# UNITED STATES PATENT AND TRADEMARK OFFICE

APPLICATION NO.	1	FILING DATE	FIRST NAMED INVENTOR	ATTORNEY DOCKET NO.	CONFIRMATION NO.	
10/046,405		01/16/2002	Minoru Aoyama	2002_0008A		
513	7590	07/28/2003				
WENDERO 2033 K STR		ND & PONACK, I	EXAMINER			
SUITE 800		•	ALEJANDRO, RAYMOND			
WASHING	ION, DC	20006-1021		ART UNIT PAPER NUMBER		
				1745		
				DATE MAILED: 07/28/2003

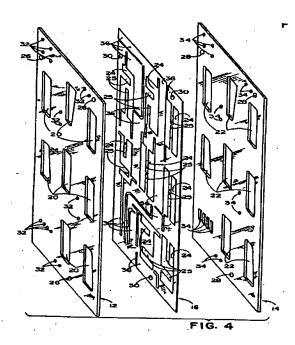
<u>Figures 1, 2, 3</u> above depict three layer component to be combined wherein the layers as combined are illustrated in <u>Figure 4</u> above.

It is apparent from *Figures 1-4* that clearance openings 20 are of a size and configuration to fit over the top of the terminals of a series of galvanic cells or batteries, in this case eight in number. Thus, there are eight openings 20 generally rectangular in configuration and large enough to extend around the periphery of the two terminals, positive and negative, of each battery (COL 2, line 67 to COL 3, line 5). Openings 22 in the upper insulation sheet 14 and opening 24 in the intermediate metal foil layer 16 are provided corresponding in number and location to openings 20 in the lower insulation sheet 12 (COL 3, lines 41-45).

Therefore, the eight openings 20, 22, 24 in respective sheets 12, 14 and 16 hold the battery cells. It is also noted that one of either the lower insulation sheet 12 or the upper insulation sheet 16 provides a configuration to hold or retain cells, thus, they act acts as the holding plate for holding the cells. Hence, the examiner has interpreted that one of the two
